Model	Fiery XJ Series (XJ170R)	Volt/Hz	Date of Modification	Serial Number
Modified Article	Parts Catalog			
Reason for Modification	Parts Catalog Correction

Please correct your parts catalog as follows.

Model	Fiery XJ Series	Volt/Hz	Date of Modification	Serial Number
Modified Article				
Reason for Modification	System software upgrade

Model: Fiery XJ Series(XJ80e only)		Date: 31-Mar-97	No: 7
Modified Article: Parts Catalog		Prepared by: N.Kaiya	
From: QAC 1st Field Information Dept.		Checked by: T. Inoue <i>T. Inoue</i>	
Reason for Modification:	<input checked="" type="checkbox"/> Parts catalog correction	<input type="checkbox"/> Vendor change	<input type="checkbox"/> To meet standards
	<input type="checkbox"/> To facilitate assembly	<input type="checkbox"/> To improve reliability	()
	<input type="checkbox"/> Part standardization	<input type="checkbox"/> Other

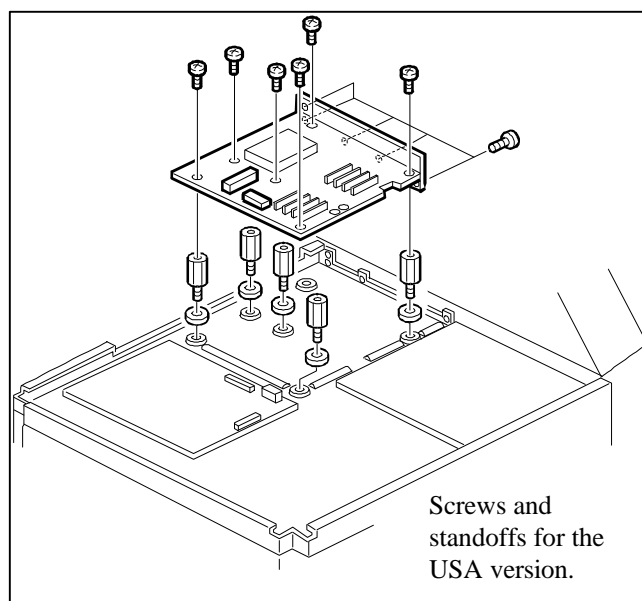
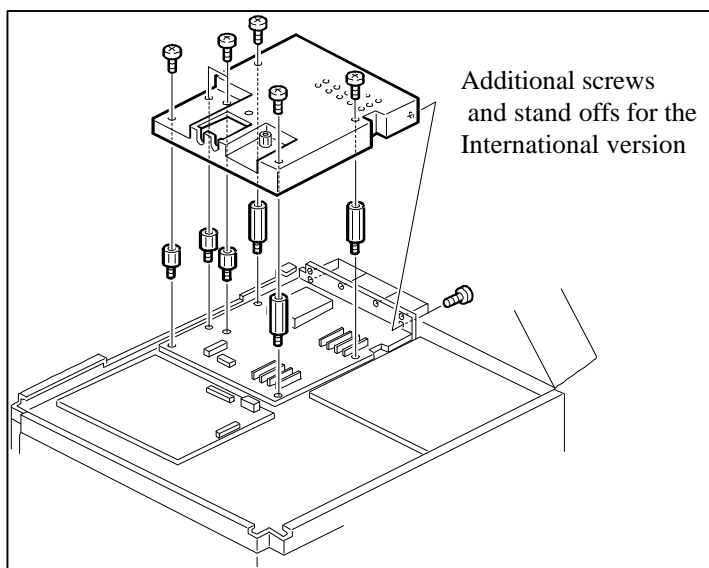
The screws and standoffs are different between the USA version model (-43) and the International version model (-44). This is because the International version requires installation of the EXU Shield Cover.

For the Disk Pack, part numbers have been separately assigned for the Mac Disk Pack and the Windows Disk Pack.

Also, please correct the index numbers in the illustration in your parts catalog. Please exchange index no.8 and index no.9.

Old part number	New part number	Description	Qty	Int	Destination	Page	Index
A7245356	A7245398	Screws and Standoffs:10007781	1-1		-43	3	4
A7245356	A7245399	Screws and Standoffs:10007782	1-1		-44	3	4
A7245364		Disk Pack - English	1-		-43,-44	3	9
	A7245376	Mac Disk Pack English:10011587	-1		-43,-44	3	9
	A7245377	Windows Disk Pack English:10011588	-1		-43,-44	3	9

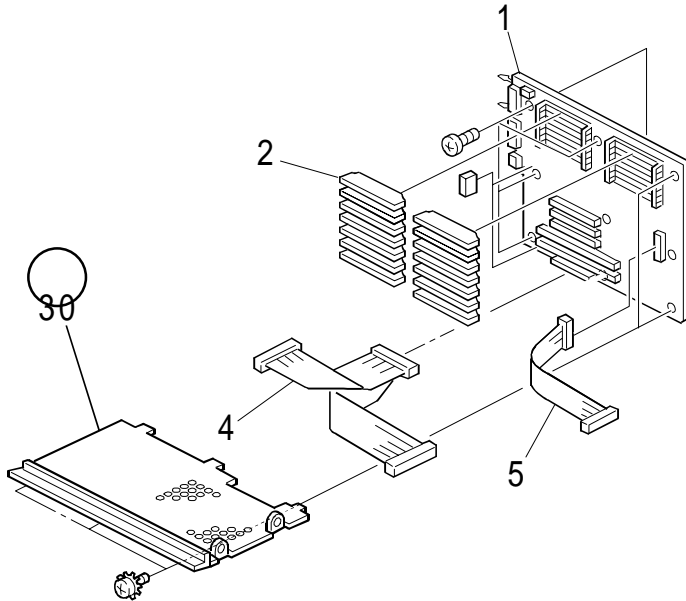
Please add the following part and the illustrations to your parts catalog (pages 2 and 3).

Old P/N	New P/N	Description	Q'ty Used	Parts Catalog		Notes
				Page	Index No.	
	A7245295	Isolation Plate	1	3	30	-62, -63, -64, -65, -66, -67 only

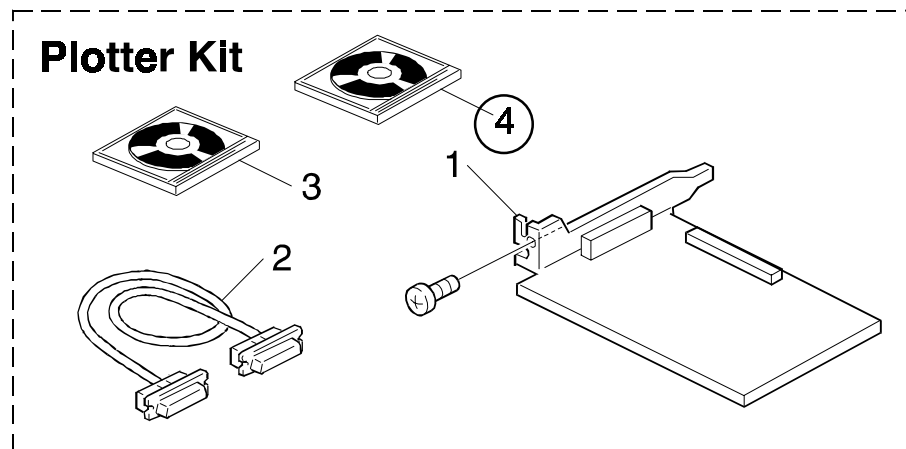
Please add the following part and the illustrations to your parts catalog (page 8 and 9).

Old P/N	New P/N	Description	Q'ty Used	Parts Catalog		Notes
				Page	Index No.	
	A7245347	CD-ROM Plotter Color Files	1	9	4	-70 only
